Project FX-08-08 Addition of mounting dimensions for wall-hung water closet fixtures

ASME A112.19.2-2008 / CSA B45.1-08 Ceramic plumbing fixtures

Draft: No. 1a
Date: March 2010

Project title: Addition of mounting dimensions for wall-hung water closet fixtures
Project No.: FX-08-08 Standard: ASME A112.19.2-2008 / CSA B45.1-08

Figure 3
Outlet dimensions for rear-outlet and
rear-spigot-outlet water closet bowls
(See Clause 4.6.1.)

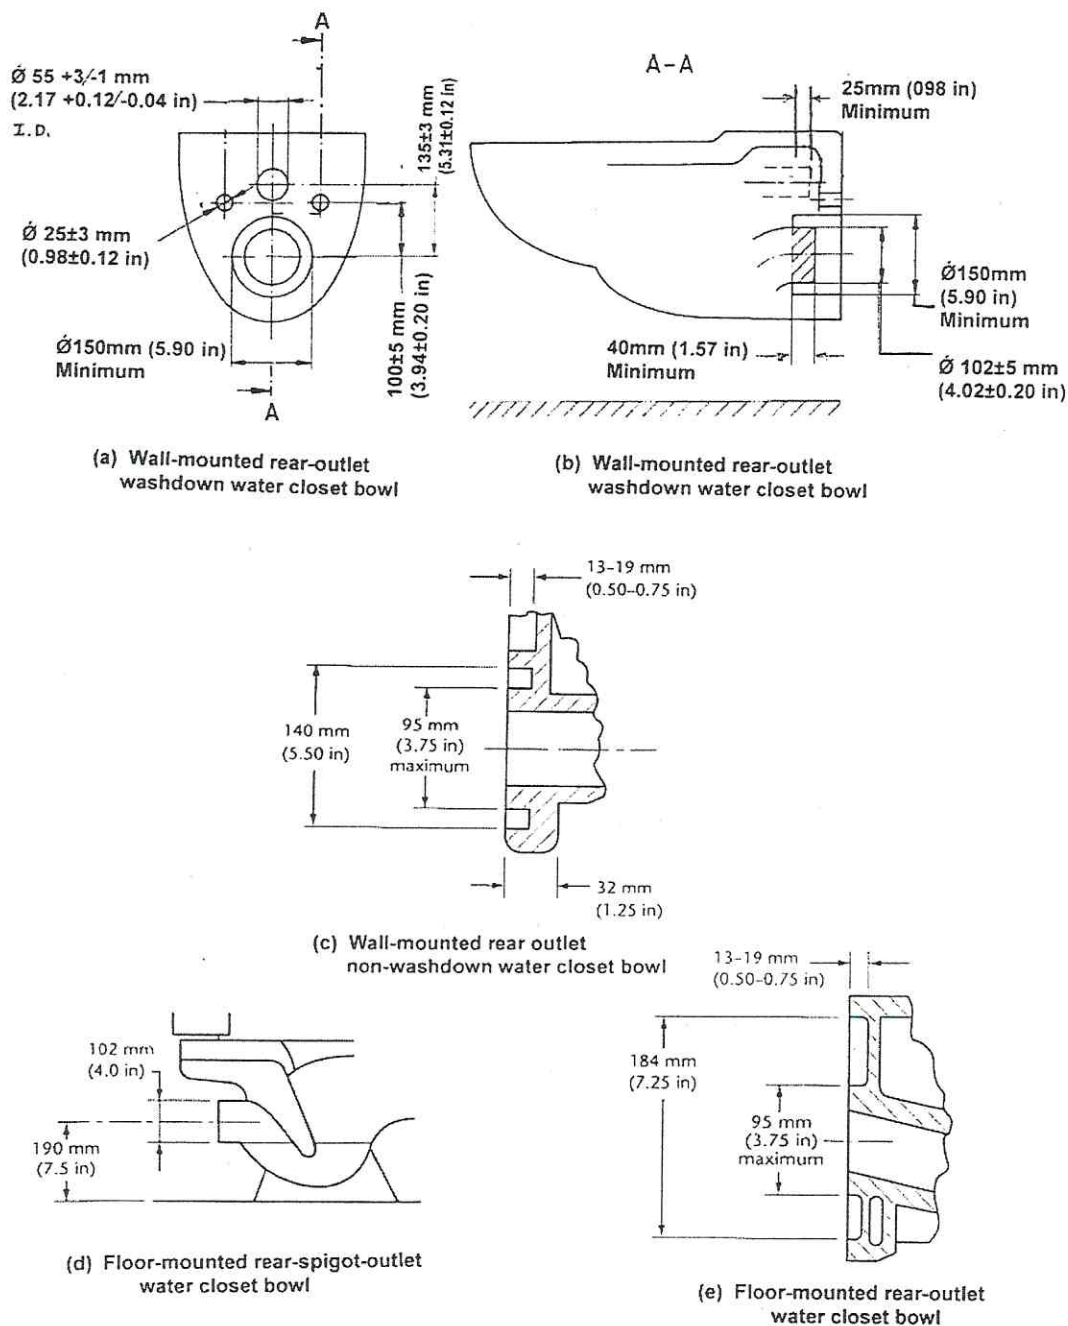
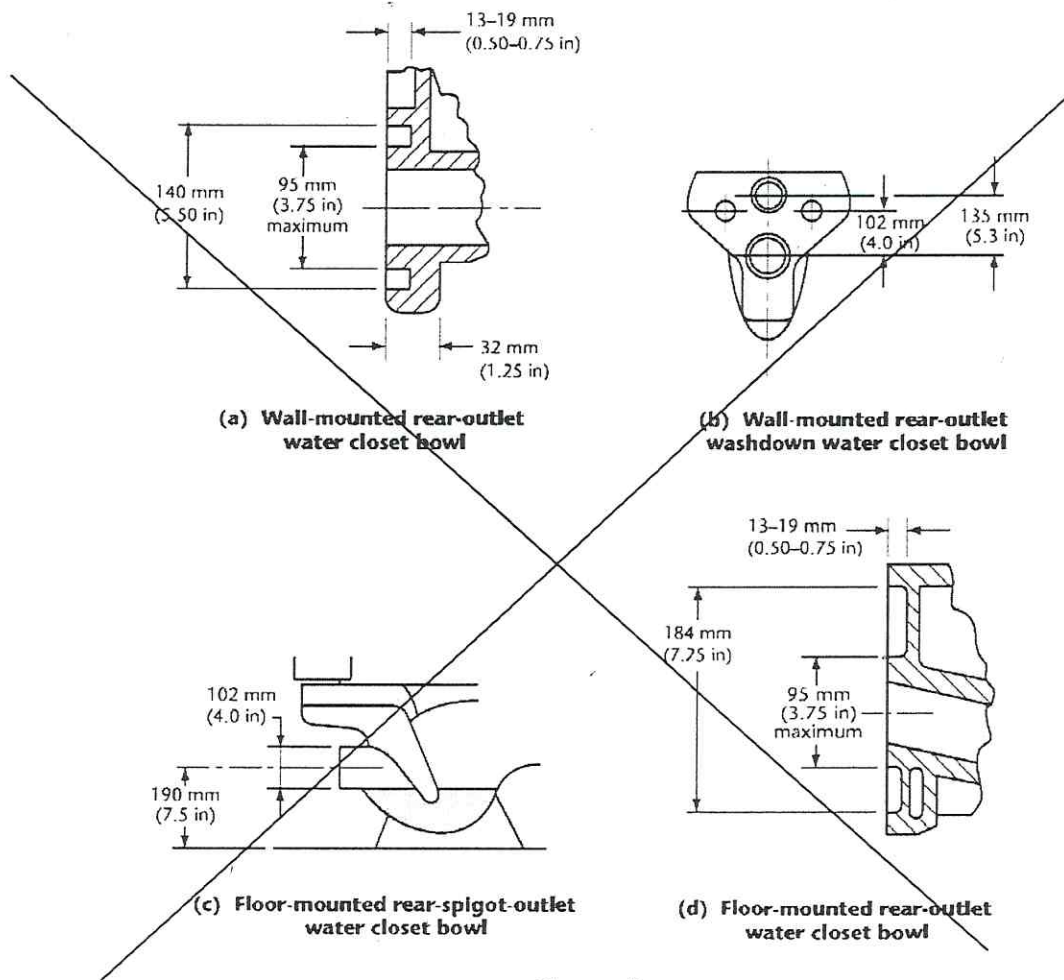
Insert the following revised figure 3:

The new figure 3 (c), (d), and (e) are the same as the existing 3 (a), (c), and (d).

Delete the following figure 3 (existing):

Presently there are missing standard dimensions for the inlet and outlet openings for wall-hung water closets that are commonly used in Europe and are being approved for use in the US and Canada. This change will harmonize the dimensional requirements to insure the proper function of the fixtures with the carriers on which they are mounted.

Figure 4
Bolt hole spacing for wall-mounted water closet bowls
(See Clause 4.6.3.)

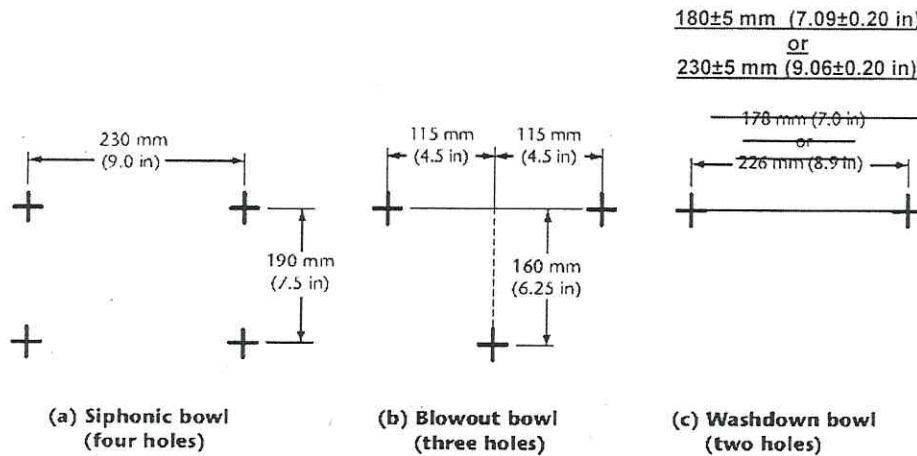
Edit Figure 4(c) as shown:
